Access Compliance Report Public Rights-of-Way (Curb Ramps)

Main Street: NEWPORT_BLV D Cross Street: GREENBRIER_RD Location: W

ADA ID: RPRK211012145620 Ramp Type:Type 1 - Perpendicular Diagonal Initial Pass/Fail: Fail Overall Compliance: No Severity Score: 2

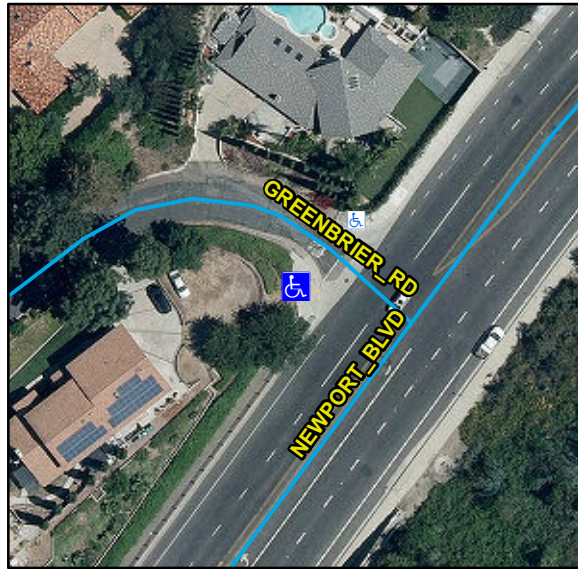
Compliance	Description	Data	Compliance	Description	Data
N/A	Ramp Length (in)	108	N/A	Flare Type LT	
Yes	Ramp Width (in)	48			N/A
Yes	Ramp Run Slope (%)	6.3	N/A	Flare Slope LT (%)	N/A
No	Ramp Cross Slope (%)	4.6	N/A	Flare Traversable LT	N/A
N/A	Landing Present	N/A	N/A	Flare Type RT	
N/A	Landing Length (in)	N/A			N/A
N/A	Landing Width (in)	N/A	N/A	Flare Slope RT (%)	N/A
N/A	Landing Run Slope (%)	N/A	N/A	Flare Traversable RT	N/A
N/A	Landing Cross Slope (%)	N/A	N/A	DWS Provided	N/A
N/A	Landing Movement Obstructed?	N/A	N/A	DWS Contrast	N/A
	Landing Movement Type	N/A	N/A	DWS Length (in)	N/A
N/A	Landing Shared	N/A	N/A	DWS Full Width	N/A
N/A	Clear Space	Yes	N/A	DWS Offset Left (in)	N/A
N/A	Clear Space To Crosswalk (in)	N/A	N/A	DWS Offset Right (in)	N/A
N/A	Marked Crosswalk 1	No	N/A	Marked Crosswalk 2	No
	Crossing 1 Direction	SE		Crossing 2 Direction	NE
	Marked Crosswalk 1 Width (in)	N/A		Marked Crosswalk 2 Width (in)	N/A

Remove & Replace Curb Ramp With Two New Directional Ramps or Equivalent.
